Service Bulletin

SUBJECT: Service Update for Inventory and Customer Vehicles
Body Harness Contact with Park Brake Bracket
Expires with Base Warranty

MODELS: 2014-2015 Chevrolet Silverado
2014-2015 GMC Sierra

4109183

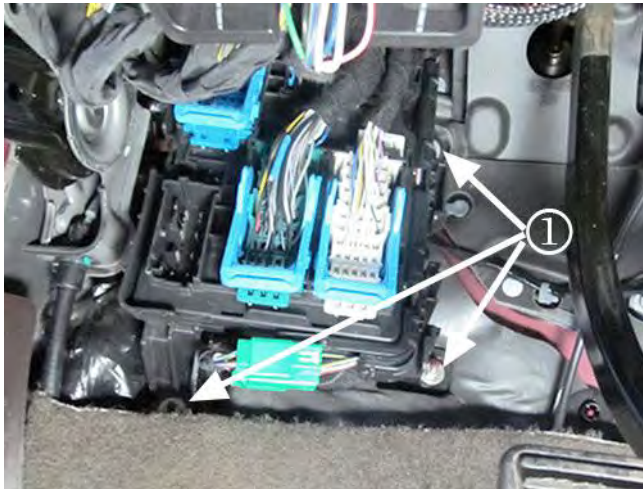
5. Locate the branch-out harness and reposition towards the body harness. A tie strap will be added around both harnesses to increase clearance to the park brake bracket.

6. Locally obtain a tie strap to secure the branch-out to the body harness. To assist installation, it may be helpful to kink the tie strap as shown in the graphic above.

7. Secure the branch harness away from the park brake bracket by adding the tie strap at the approximate location shown in the graphic above. Verify increased clearance between the harness and the park brake bracket.
8. Reconnect the park brake switch terminal (1) and attach the harness retainer (2) from the body stud.
